NATURAL FEATURES AND LANDSCAPES

- [1] This Recommendation Report relates to the Natural Features and Landscapes chapter of the PDP and contains the Hearing Panel's recommendations to Council on the submissions and further submissions received on that chapter.

<u>RIDGELINE</u> ²⁷	<u>Ridgeline is the line marking or following the ridgetop that forms a continuous elevated crest and is the line of intersection at the top of opposite slopes</u>

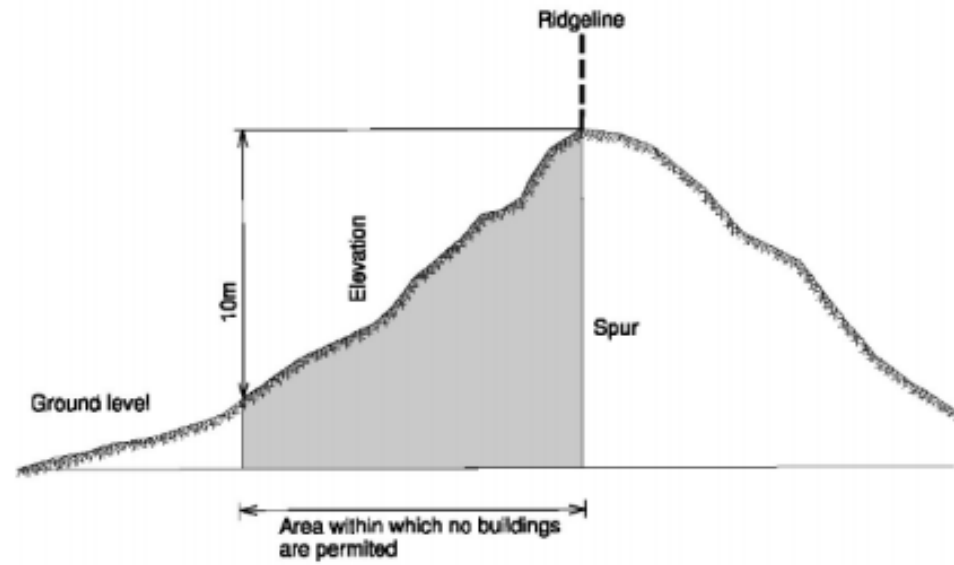
- [18] We accept that only minor modification is required to the definition of 'building node' (to insert 'generally') but agree that the other amendments requested by The Stations, DHL and CFSL were not substantiated by conclusive evidence. We do not support NCFF's request to delete the definition as in essence we agree there is a need for controls regarding building nodes for the reasons stated in the Section 42A Report. The inclusion of a definition of 'Ridgeline', together with a diagram, as requested by SDC is appropriate.
